Written submission from the Ottawa River Institute

Application from the CNL to amend its Chalk River Laboratories site licence to authorize the construction of a near surface disposal facility

Ottawa River Institute submission for the NSDF licensing hearing

April 11, 2022

Figure 1

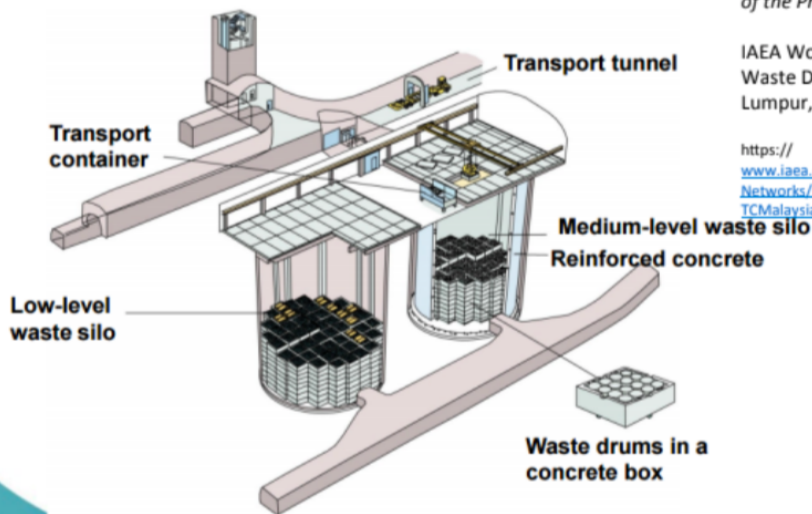
Instead, we believe Canada can and should build state-of-the-art, world-class facilities that will keep radioactive wastes out of the biosphere for as long as they remain radioactive and hazardous. Other countries are ahead of Canada on this. By way of example, here are two illustrations of what the Finnish people are doing with their radioactive wastes.

Figure 1 above shows below ground silos for low level and intermediate level waste. These are made out of reinforced concrete.
